WR-1 Federal and Provincial Environmental Impact Statement Information Request Responses
2022 December

No.	Department/ Agency	SME	Section Table or Figure	Pg. #	Information Request or Summary of Comment	Response by CNL
					EIS	
					General	
1.	Canadian Nuclear Safety Commission (CNSC)	C. Cianci	EIS - All - General	N/A	<p>Comment: The terminology in the Environmental Impact Statement (EIS) documentation to identify Indigenous peoples is not, in all cases, appropriately used. The use of the term “First Nations” is not interchangeable with the term “Indigenous peoples”. When referring to both First Nation and Métis communities either indicate this explicitly or indicate “Indigenous communities”. Expectation to Address Comment: Please review and revise the EIS documentation accordingly with the use of the appropriate terms.</p>	<p>Incorporated:</p> <p>The terminology in the Environmental Impact Statement (EIS; Golder 2022) used to identify Indigenous peoples was reviewed and revised, as necessary, to ensure the appropriate terms were being used. Throughout the EIS, the terms “Aboriginal”, “Indigenous”, “First Nations”, and “Métis” have been used. Each have a specific meaning and are

Figure A-2: PSD Results - 18101723 Fine Aggregate

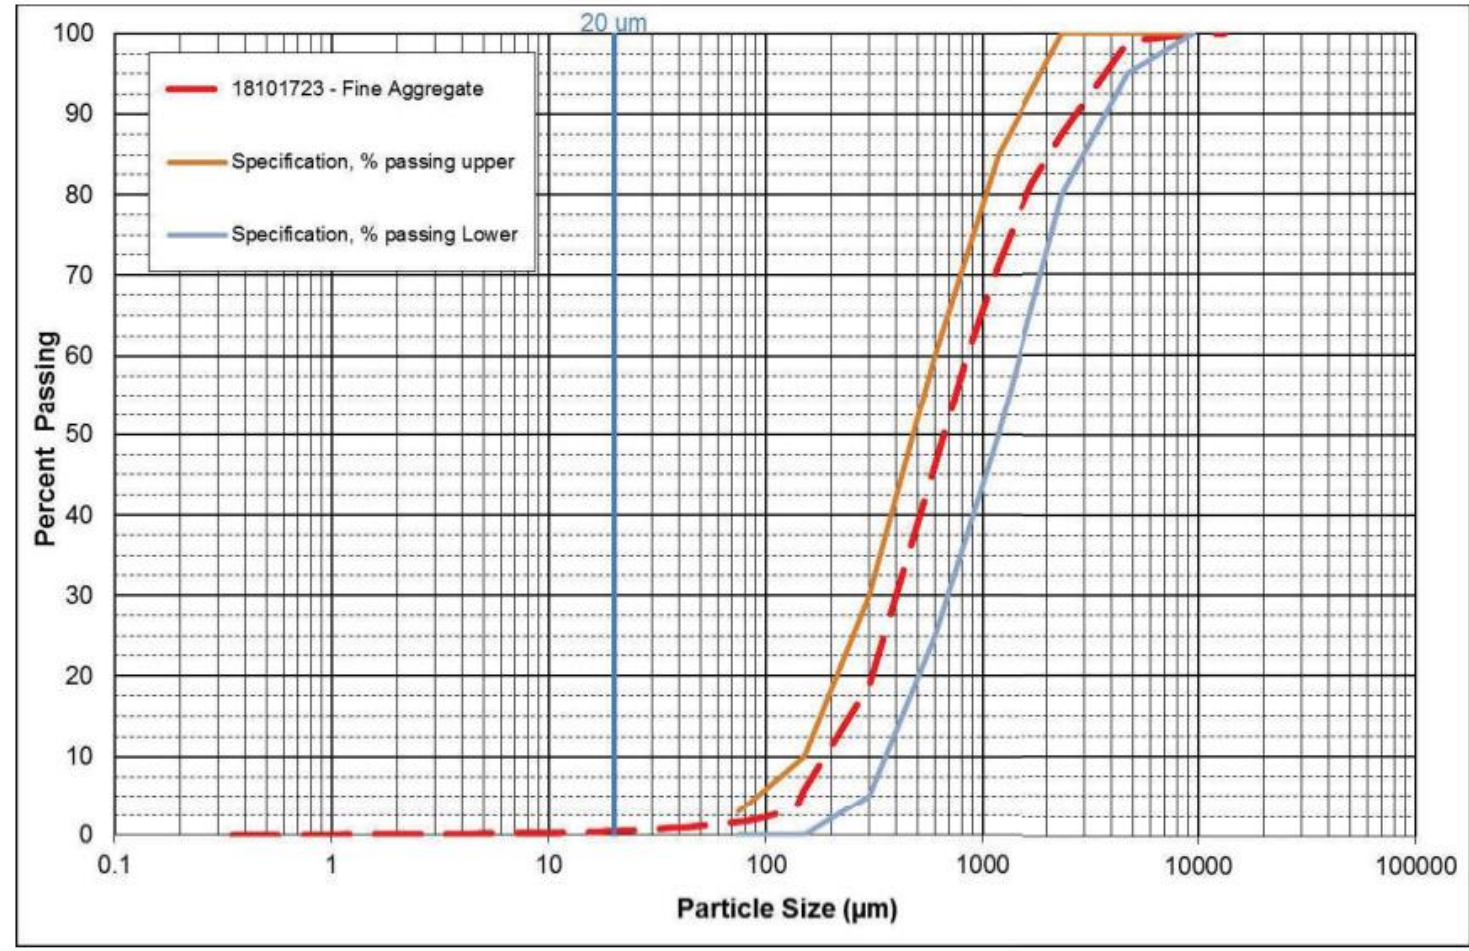
<p>Details on the grout components that can influence airborne emissions, such as Portland cement, fly ash, and sand, are provided in the Attachment A-1 and A-2 of the Grout Formulation Testing Report (Golder 2022a). Portland cement is Type GU hydraulic cement, an industry-standard product meeting the requirements of ASTM C150/CSA A3001. Fly Ash is a Type F fly ash, also an industry standard product meeting the requirements of ASTM 618/CSA A3001. Project-specific material is the fine aggregate (sand) for which the particle size distribution graph is provided below, with further testing detailed in Attachment A-1/A-2 of the Grout Formulation Testing Report.</p>	Material	Quantity per m ³	Portland Cement	89 kg	Fly Ash	297 kg	Sand	1,570 kg	Gravel	0 kg	Water	232 kg	Polycarboxylate Polymer	1.77 L	Diutan Gum Based Viscosity Modifying Admixture	260 g
Material	Quantity per m ³																					
Portland Cement	89 kg																					
Fly Ash	297 kg																					
Sand	1,570 kg																					
Gravel	0 kg																					
Water	232 kg																					
Polycarboxylate Polymer	1.77 L																					
Diutan Gum Based Viscosity Modifying Admixture	260 g

CNL used EPA AP42 Section 11.12 for emission factors for batching of concrete (as described in EIS Section 6.2.1.7.1). CNL considers the use of these factors reasonable since the project will be using conventional practises during the concrete/grout batching process. The average and maximum emission rates from grout production are provided in Table 12 and 13 respectively in Appendix 6.2-2 of the EIS and are shown below:

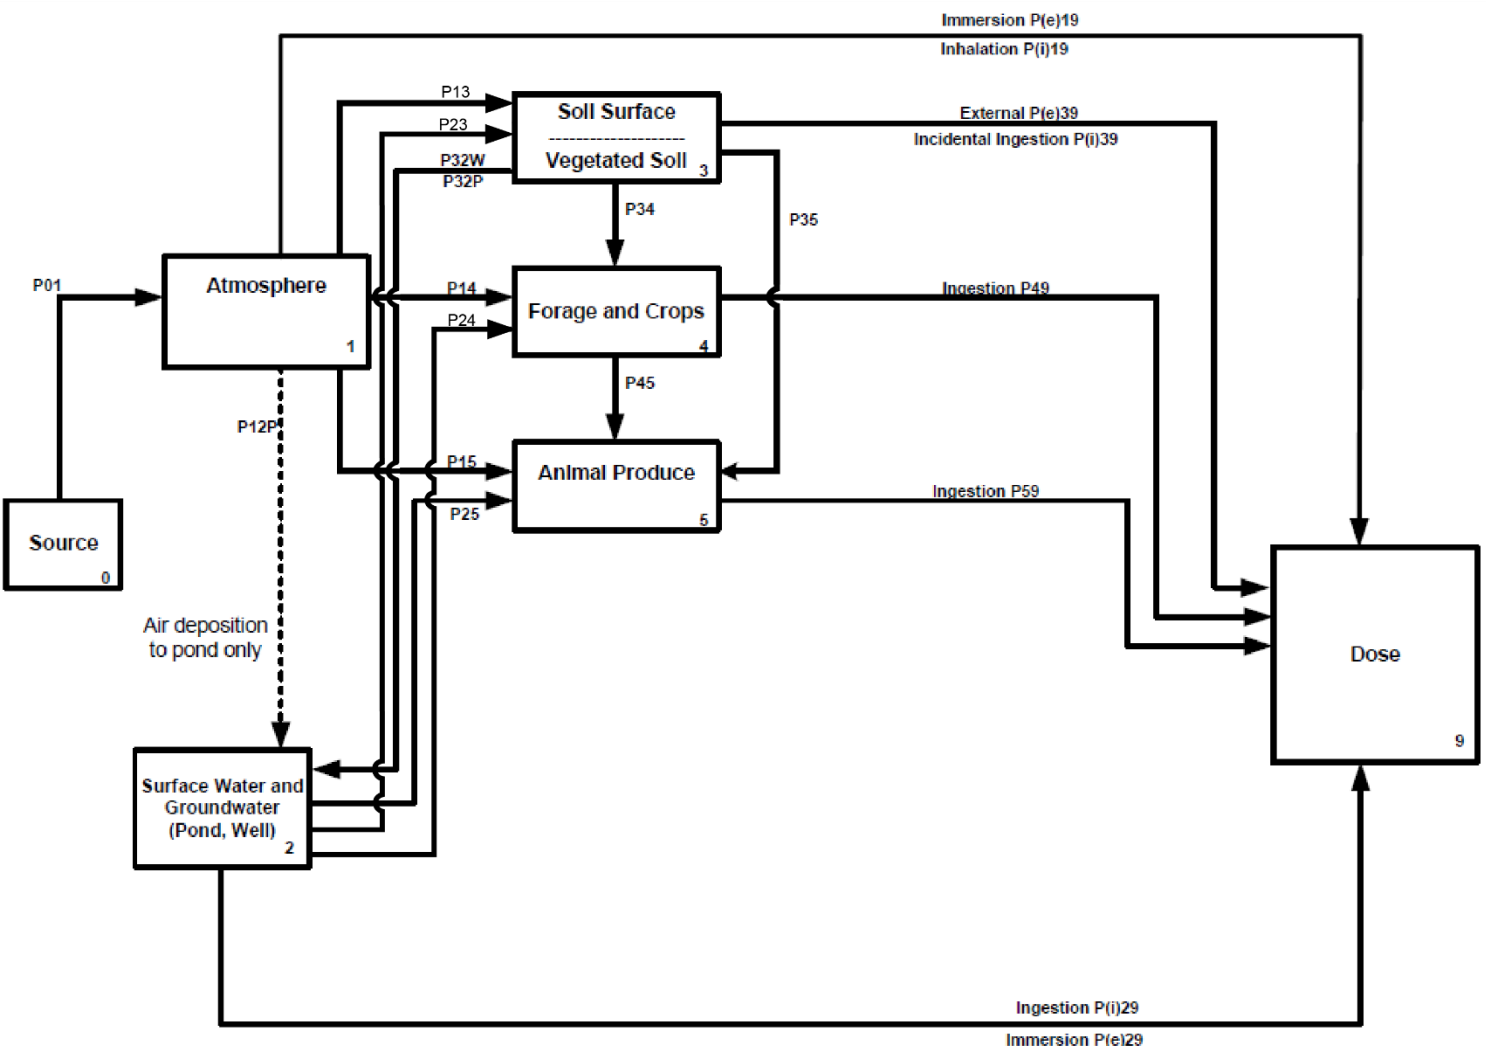
173.	HC		ERA - Figure 4.2	4.8	<p>Comment: The irrigation pathway is missing from Figure 4.2 but is mentioned in the text. Expectation to Address Comment: Make the appropriate correction and update, where appropriate, other relevant sections of the EIS and ERA documentation,</p>	<p>Incorporated:</p> <p>Figure 4-2 in the Environmental Risk Assessment (ERA; EcoMetrix 2021) has been updated to include the irrigation pathway.</p> <p>Change to ERA:</p> <p>P23 and P24 have been added to Figure 4-2 (see revised figure below) to reflect the irrigation pathway, as they were modeled in the ERA.</p>

Figure 5.4.3-2: Total Activity per Solid Mass (Bq/g) over time for the WRDF as compared to the Prairie Flats Near Surface Uranium Deposit in British Columbia, Canada

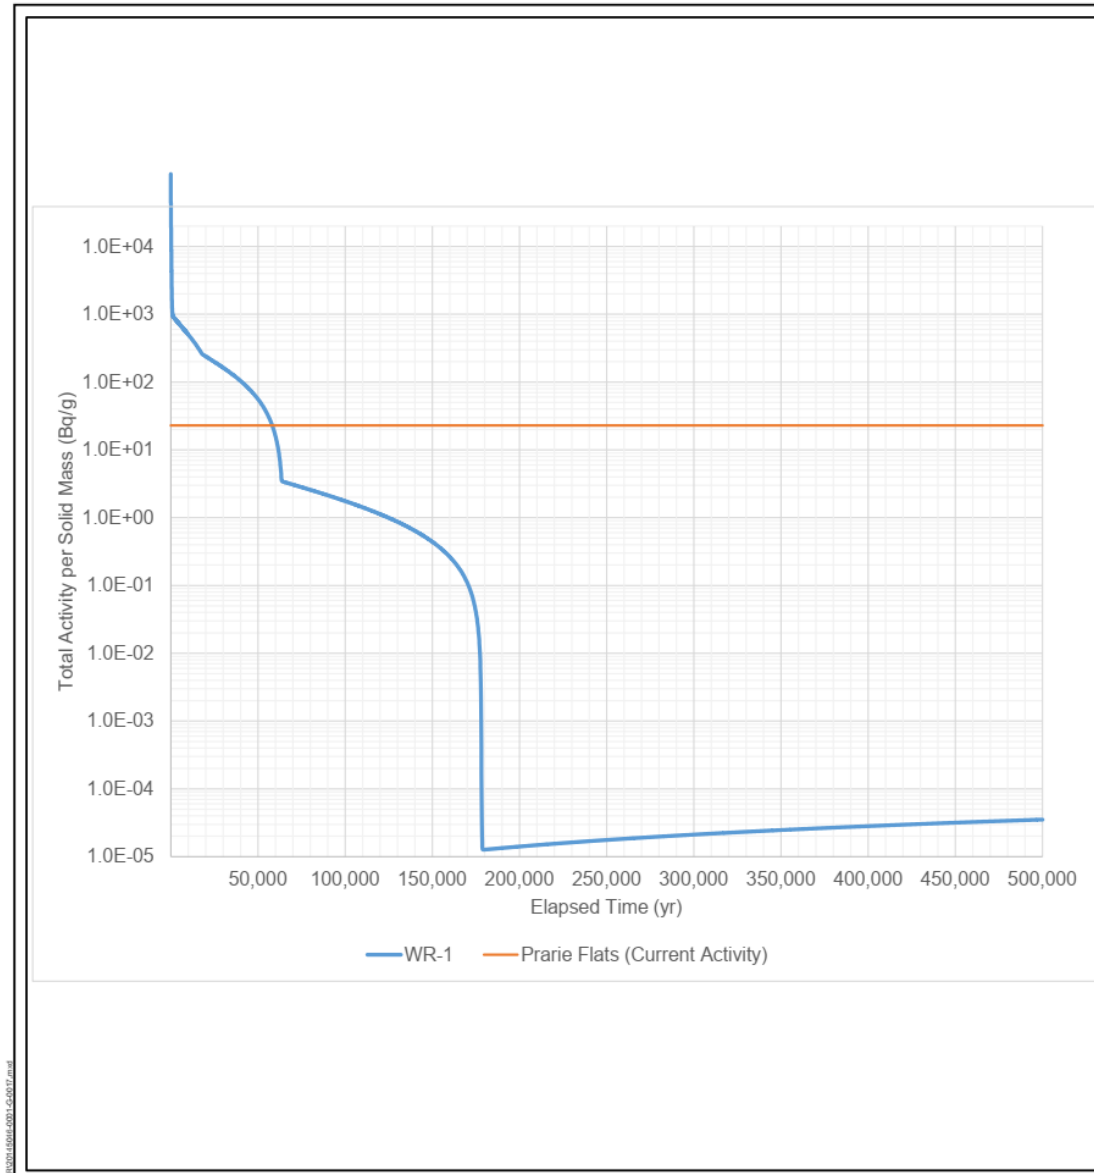
189.	CNSC	E. Dagher/ R. Goulet/ J. Brown/ S. Nguyen	DSAR - Section 2.4.3, Figure 2.4.3-1 Time frame	58 to 62	<p>Comment: Selection of a time frame should be supported using a multiple lines of evidence approach, which must encompass the time frame when the maximum impact is predicted to occur, as per P-290. When assessing multiple lines of evidence to support the time frame, consideration should be given to the source-term and the longevity of the source-term, the use of natural analogues, and the period with maximum exposure to critical receptors as per an acceptable Normal Evolution Scenario. It is not clear within Section 2.4.3 of the DSAR how CNL has used a multiple lines of evidence approach to support their selection of an assessment time frame. For example, considering the source-term inventory and longevity, based on CNSC's independent estimates of the reactor core and heat transport system decay rates (using CNL data), the radionuclide inventory will decay to background in 300,000 years (if daughter products do not contribute significantly to the long-term dose) yet the selected assessment timeframe is 60,000 years. Furthermore, a natural analogue may be used to support the proposed assessment time frame, however no information has been provided to support the acceptability of using the Prairie Flats uranium deposit as a natural analogue to define the time frame (see related comment on Natural Analogues). The use of a natural analogue, which has not been shown to be similar to the proposed facility and its site, alone, is not</p>	<p>Incorporated:</p> <p>CNL has significantly revised Section 5.3 of the Decommissioning Safety Assessment Report (DSAR; Golder 2021) to provide evidence to support CNL's rationale for the timeframe selection and explain CNL's estimated decay of the radionuclide inventory and how this estimate was used to support the proposed assessment timeframe.</p> <p>Change to DSAR:</p> <p>Section 5.3 of the DSAR has been revised to include the following text:</p> <p><i>"The assessment timeframe is 10,000 years. The timeframe is established in compliance with the CNSC's REGDOC-2.11.1, Volume III (CNSC 2018a), which requires that, "the assessment of future impacts of radioactive waste on the health and safety of persons and the environment encompass the period of time when the maximum impact is predicted to occur." Per Section 7.4 of CNSC's REGDOC-2.11.1, Volume III (CNSC 2018a) there is no time limit associated with the statutory objective to "prevent unreasonable risk, to the environment and health and safety of persons..." (Nuclear Safety and Control Act, 9(a)(i)). Instead, the determination of the appropriate time period is part of the assessment process.</i></p> <p><i>The approach taken to determine the assessment timeframe accounted for the following elements:</i></p> <ul style="list-style-type: none"> <i>hazardous lifetime of the contaminants associated with the waste;</i> <i>duration of the operational period (before the facility reaches its end-state);</i> <i>design life of engineered barriers;</i> <i>duration of institutional control; and</i> <i>frequency (probability) of natural events and human-induced environmental changes (e.g., seismic occurrence, flood, drought, glaciation, climate change).</i> <p><i>The following sections provides rationale for the selection of the 10,000-year timeframe and how each of the criterion listed in the REGDOC-2.11.1 has been met and supports the proposed 10,000-year timeframe.</i></p> <p>Hazardous Lifetime of the Contaminants</p> <p><i>CNL has determined the hazard level of each contaminant in the WR-1 [Whiteshell Reactor 1] by calculating an annual dose rate, or [Hazard Quotient] HQ for the expected exposure pathways. For radionuclides, the total dose rate is the sum of dose contributions from all radionuclides; and the maximum total</i></p>

No.	Department/ Agency	SME	Section Table or Figure	Pg. #	Information Request or Summary of Comment	Response by CNL
						<p><i>radionuclides at several locations containing subsurface uranium deposits, including Prairie Flats, met regulatory guidelines for the protection of the health of human and non-human biota, and that "no adverse effects are expected." Experience has shown that a sound knowledge of the potential radiological effects associated with the presence of these natural deposits has generally resulted in no measurable effect on human health (CCME 2007b).</i></p>
